SERVICE BULLETIN

M1610

M1610 (REV B): RECALL 0184 - 2023 CVO STREET GLIDE (FLHXSE) AND ROAD GLIDE (FLTRXSE) BRAKE LINE CLAMP

Figure 2. P-Clamp Orientation

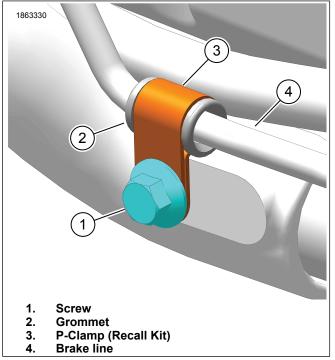
- 1. See Figure 1. Remove and retain screw (1).
- 2. Remove and discard Original Equipment (OE) brake line clamp (2).
- 3. See Figure 2. Install **new** P-Clamp (3) from recall kit (Part No. 91500116).
 - a. Make sure P-Clamp (3) is properly orientated.
- Install screw (1). Tighten. Torque: 80–97 in-lbs (9–11 N·m)
